Report to Planning and Environment Committee

Subject: 2419361 Ontario Inc.
934 Oxford Street West
File Number: Z-9678, Ward 8

Date: January 30, 2024

Figure 3 - Conceptual Site Plan (August 2023)

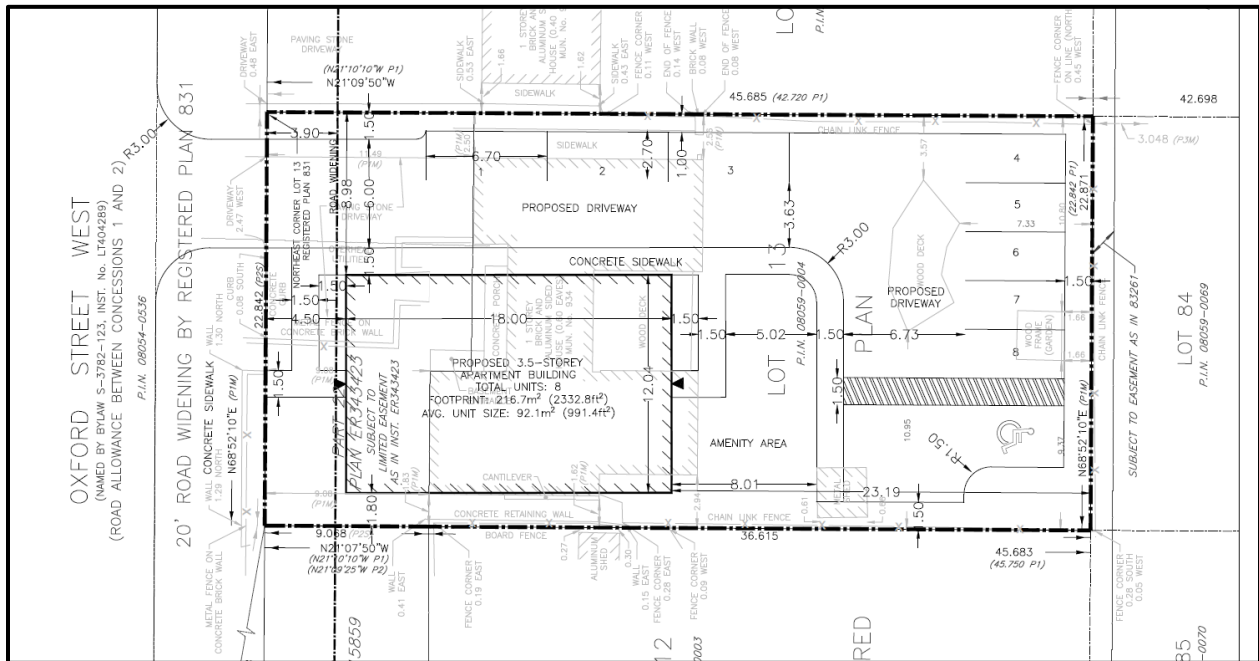
Staff identified multiple issues relating to form, such as building orientation, setbacks, and site layout. Policy 291 of The London Plan outlines that building features such as principal building entrances should face the public right-of-way, as to establish an active frontage and pedestrian access. The proposed building has the primary entrance facing east, toward the drive aisle. Renderings show that the wall facing the public right-of-way contains only small windows and does not follow the above policy.

building in such a way that the west interior side yard functions as the building's rear yard. The building entrance and layout also exacerbate setback issues. With the proposed 3.5 storey height (13 metres), a 1.8 metre setback is proposed between the building and the westerly property line. At the proposed height, a 4.5 metre interior side yard setback would normally be required: this separates the building from adjacent properties and developments, provides space for site functions and amenities, and reduces privacy concerns (TLP 953_3). In this case, the 1.8 metre setback does not allow appropriate separation, reducing needed interior side yard space to provide appropriate buffering and creating potential privacy concerns.

The site plan also does not show certain required amenities, such as waste storage (TLP 266), snow storage, and outdoor bicycle parking (TLP 280). While staff recognize the amenity space to the south of the building as a positive design element, the above omitted site features are also needed, and likely would default to the existing area used for amenity space limiting opportunity for appropriate and functional onsite amenity space for the residents. The site also requires a two-way driveway for ingress and egress and the parallel parking spaces show along the east portion of the driveway are not acceptable or safe.

The intent of a front yard depth is to ensure sufficient space between the buildings and front lot line to accommodate all site functions while still facilitating a pedestrian oriented development. The proposed 4.5 metre front a yard setback does not reflect the required road widening requirement. As per Table 6 of The London Plan, the width requirement for Oxford Street West, an urban thoroughfare, outside of the Primary Transit Area, is 22.5 metres. This leaves the proposed building as encroaching into the proposed right-of-way.

The west interior side yard setback is 1.8 metres, whereas the standard setback required would be 4.5 metres. As the building is oriented toward the east, the interior side yard setback effectively acts as a rear yard with multiple unit windows facing west, and the reduced setback significantly impacts the privacy to and from the proposed development into the existing property to the west (940 Oxford Street West). A development with the main entrance and individual unit windows oriented north-south to the street or the rear yard would be more appropriate and mitigate privacy concerns.

- 5. **Remove the parallel parking along the drive aisle** for unobstructed vehicular circulation and creating a safe pedestrian environment.
- 6. **Provide adequate landscape buffer between the property line and the drive aisle/parking** to avoid any negative impacts on the adjacent properties. TLP 278

Figure 5 – Lotting pattern for 934 Oxford Street West and adjacent lots

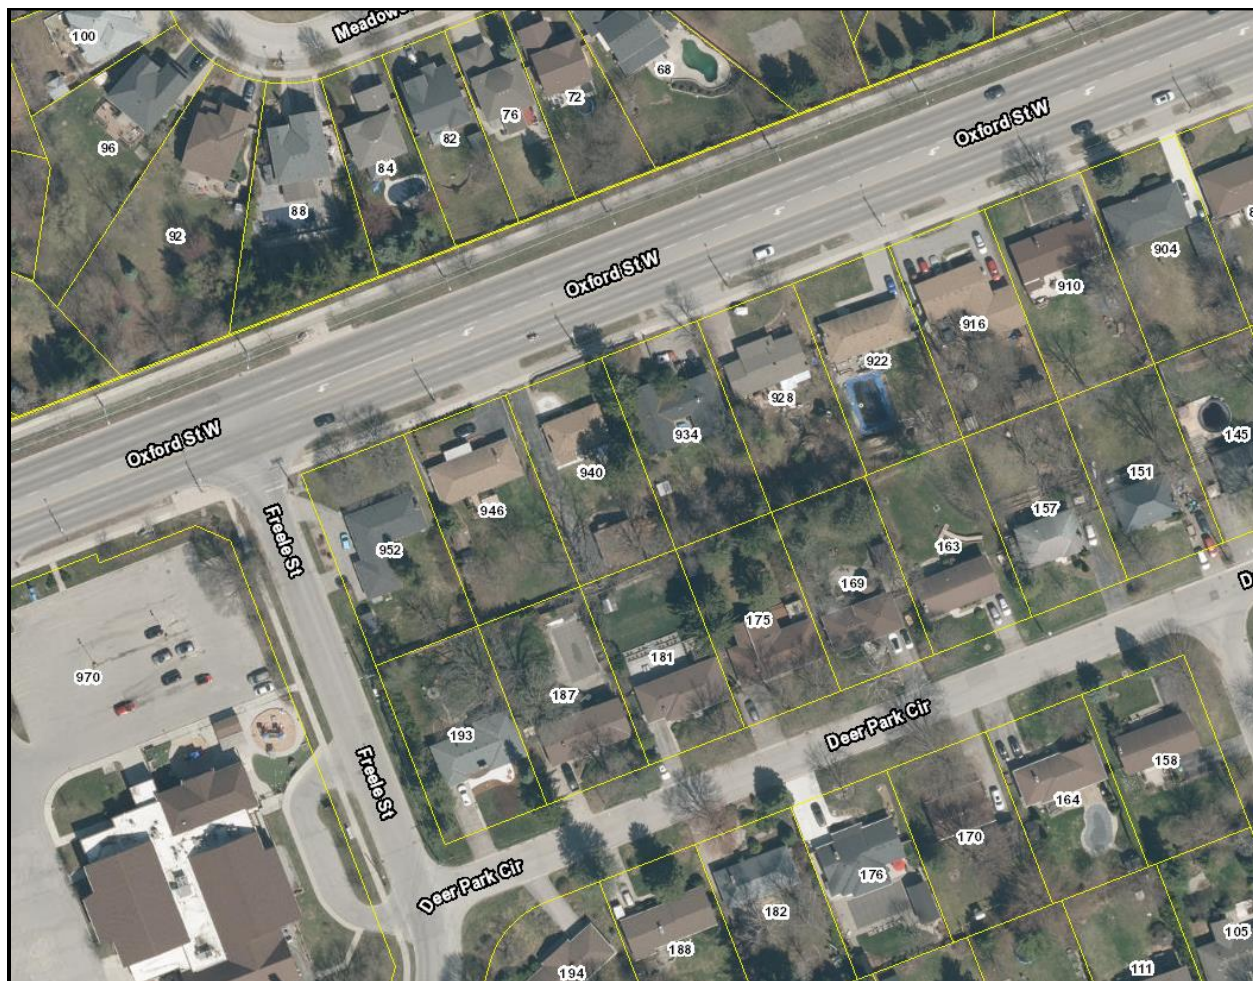
The proposed development and its issues related to form and intensity cause potential larger-scale issues relating to future development within this section of Oxford Street. Given the consistent lot fabric on the south side of Oxford Street West, (see figure 5) Staff are concerned that similar, development could occur creating long term planning impacts to the area. Staff are supportive of intensification along this corridor, including within apartment forms, however appropriate land consolidation must occur to the achieve lot frontages and areas that can appropriately accommodate the proposed intensity and required onsite functions.

Key direction 8 of The London Plan requires thinking long-term when making planning decisions to consider the implications of site-specific planning decision within the context of the 'big picture' (62_3). If approved as proposed, the proposed development would set a precedent for more properties along Oxford Street West to develop in a similar manner, leading to a large number of driveways along the road and not developing in a manner in keeping with Access Management Guidelines. While the proposed intensity can be considered appropriate within the Neighborhood Place Type along Urban Thoroughfares, developments occurring as a result of consolidation with fewer individual driveways would be preferred in similar cases.
